No. **25-92, CD1**

RESOLUTION

APPROVING A CONCEPTUAL PLAN FOR A PLANNED DEVELOPMENT-RESORT PROJECT TO MODIFY THE BOUNDARIES OF THE HILTON HAWAIIAN VILLAGE MASTER PLAN AREA, AND ALLOW FOR CERTAIN IMPROVEMENTS, INCLUDING THE CONSTRUCTION OF A NEW HOTEL TOWER, IN WAIKĪKĪ, O'AHU.

Site Plan

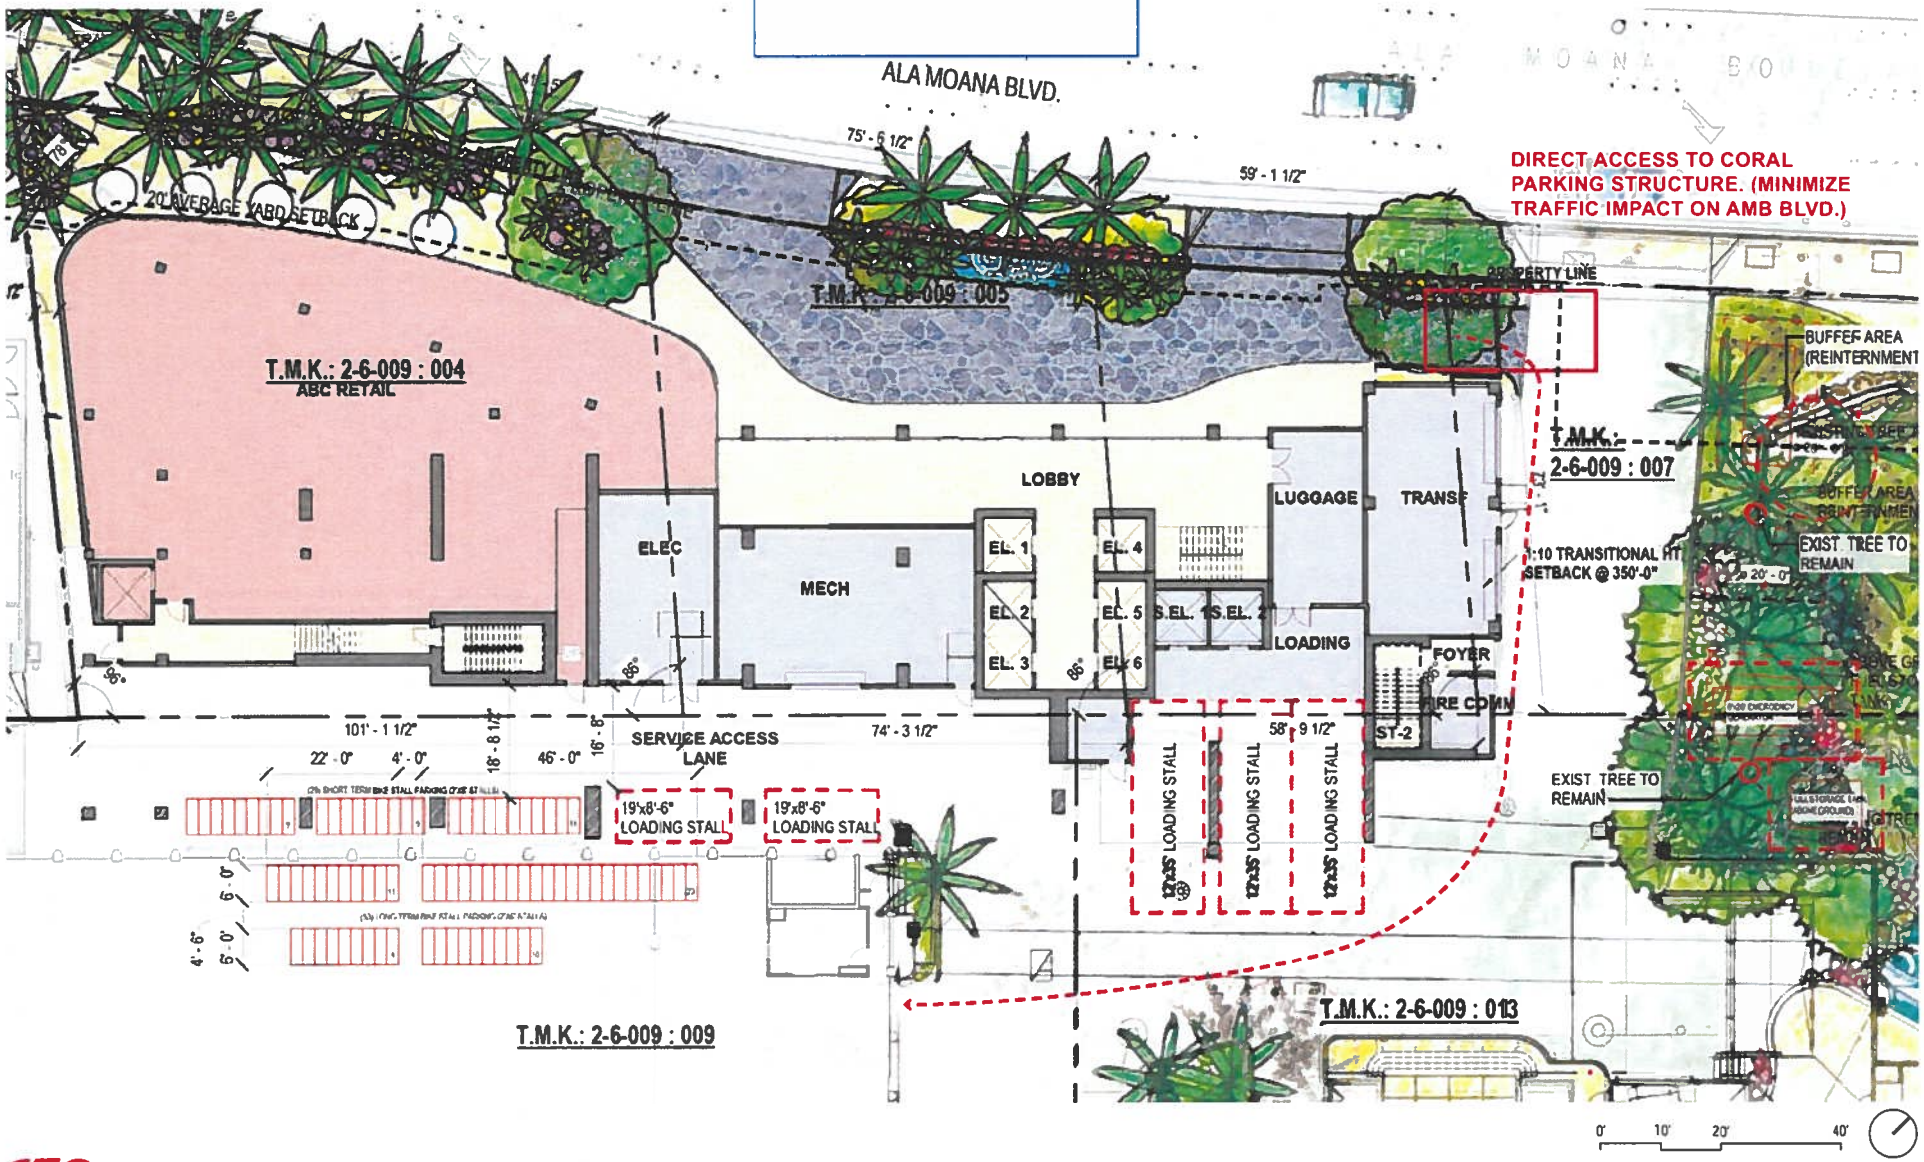
a. Improved pedestrian access at the ground level through the Project site to provide direct access to the interior of the HHV property, and additional pedestrian oriented ground-level features to create visual and physical connections across the HHV property;

b. Relocation of the landscaping (currently proposed between the sidewalk and the porte cochere) to along Ala Moana Boulevard to serve as a buffer between pedestrians and vehicles;

c. A gently meandering pedestrian pathway along Ala Moana Boulevard, similar to the pedestrian pathway fronting Fort DeRussy Park;

d. Elimination of the new proposed curb cut to exit the porte cochere onto Ala Moana Boulevard (due to conflicts between exiting vehicles, pedestrians, and other vehicles);

e. Locations for short-term and long-term bicycle parking spaces that satisfy the requirements of the Land Use Ordinance ("LUO"); additional bicycle parking spaces may be required if recommended as a Traffic Demand Management ("TDM") strategy in the Project's updated Traffic Management Plan ("TMP");

f. Detailed calculations for the averaging of yard setbacks;

g. Use of pavement textures for a consistent connection between the Project's new tower and Kālia Gardens; and

h. Proposed building color and building materials that are consistent with the WSD design standards and guidelines.

EXHIBIT N

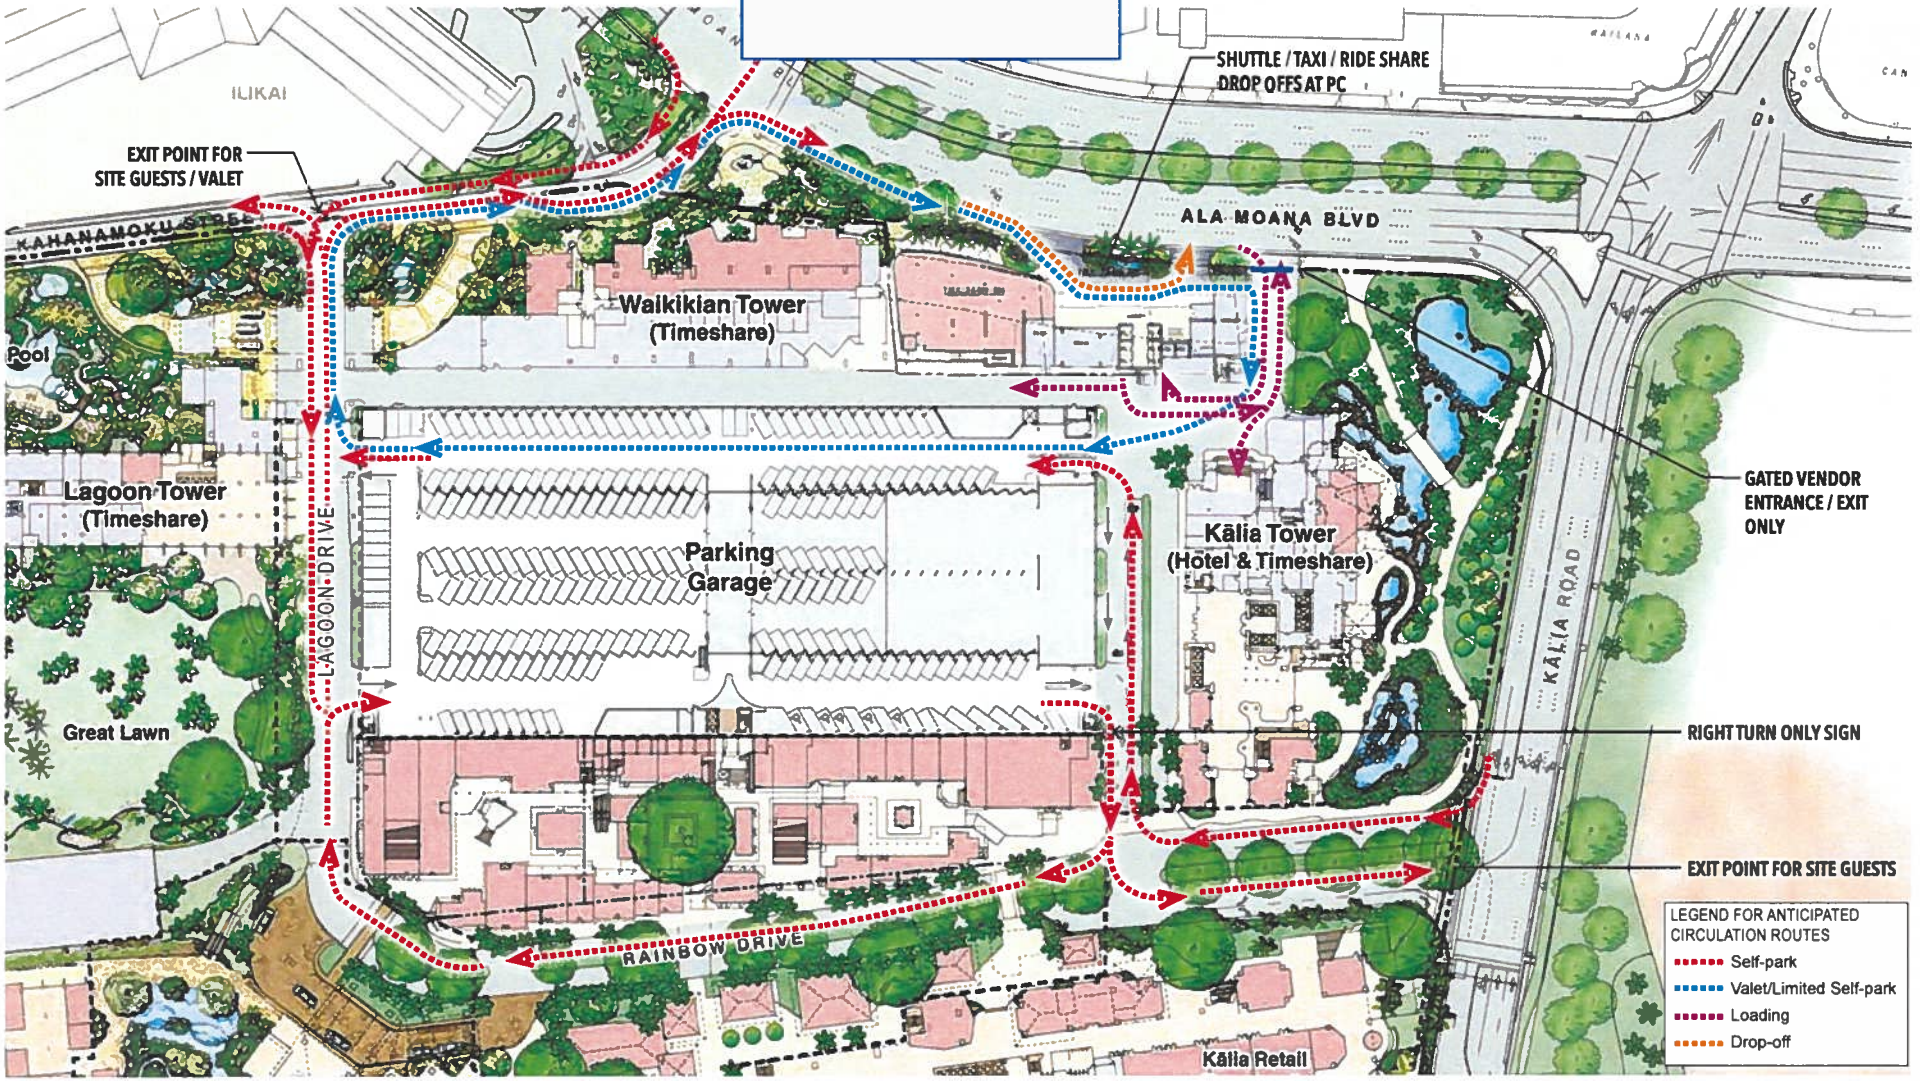
a. The trip distribution assumptions described in TIAR Table 2 and Figure 5 suggest that all projected peak traffic hour trips approach the Project site from the west and most exit Ala Moana Boulevard at Kahanamoku Street. The remaining 34/38 (A.M./P.M. peak traffic hour) vehicles would proceed toward the porte cochere, but none would exit the porte cochere to Ala Moana Boulevard;

b. The 47/73 (A.M./P.M. peak traffic hour) Project-related vehicles that leave the HHV via Kahanamoku Street and turn east onto Ala Moana Boulevard are the only trips generated by the Project that impact the Kālia Road intersection; and

c. The porte cochere exit driveway is at the edge of one of the two Kālia Road right-turn only traffic lanes on Ala Moana Boulevard, so vehicles leaving the Project site, especially during peak traffic hours, would have to turn right onto Kālia Road.

a. Revise the trip generation assumptions to reflect the anticipated use of the porte cochere as the primary guest access;

b. A description of all existing and proposed uses (for example, loading areas, parking, etc.) of the service road and the direction (enter only) of traffic on the Ala Moana Boulevard driveway;

c. A safety impact assessment, with queuing and storage depth analysis that considers the combined use of the service driveway and porte cochere driveways;

e. Proximity of the three driveways (porte cochere entrance and exit, existing service road) to each other and the Kālia Road intersection introduces multiple significant potential conflict points among vehicles, pedestrians, and bicyclists, which must be more adequately addressed.
